Access Compliance Report

Public Rights-of-Way

Intersection ID: 10503	Main Street: N_GRAHAM_ST	Cross Street: PLYMOUTH_AV	Location: E
ADA ID: 68542448A4B0	Ramp Type: PerpDiag	Initial Pass/Fail: Pass	Overall Compliance: No
Severity Score: 17.75			
Codes/Mitigation Info/Possible Solution		Field Measurements/Component Compliance

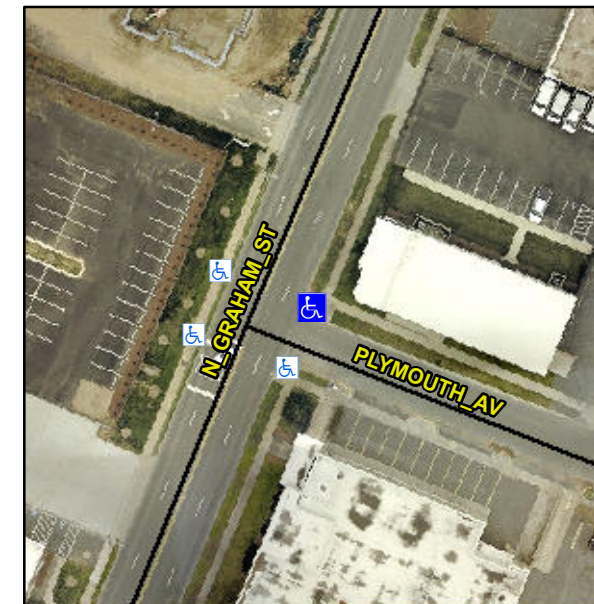
Remove & Replace Curb Ramp With Two New Directional Ramps or Equivalent. Grind Gutter Lip.

R304.5.3, R304.2.1, R305.1.4, R305.2, R302.7, R302.7.2
